Product Bulletin

PRODUCT BULLETIN: PB#B3003

DATE: February 18, 2003
REF: RD975F and RD11KF
SUBJECT: Installation of Air Dump Valves
EFFECTIVE: Immediately

Bracket being removed

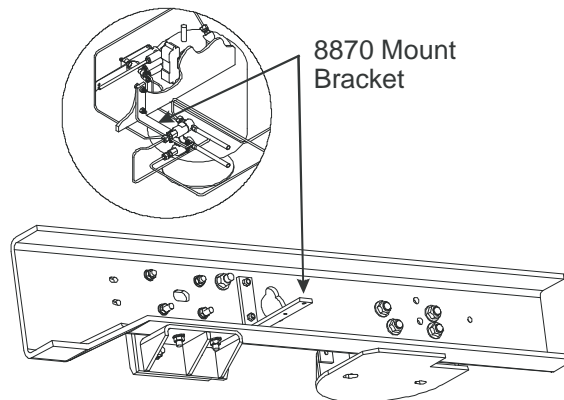
In order to bring the RD975F and RD11KF in line with the rest of the RD series, Tuthill Transport Technologies is removing the air dump valve mounting brackets from the upper air spring mounts.

Tuthill recommends mounting the air dump valves inside of the frame rails, utilizing the 8870 bracket. The 8870 bracket is provided with Tuthill supplied air control kits.
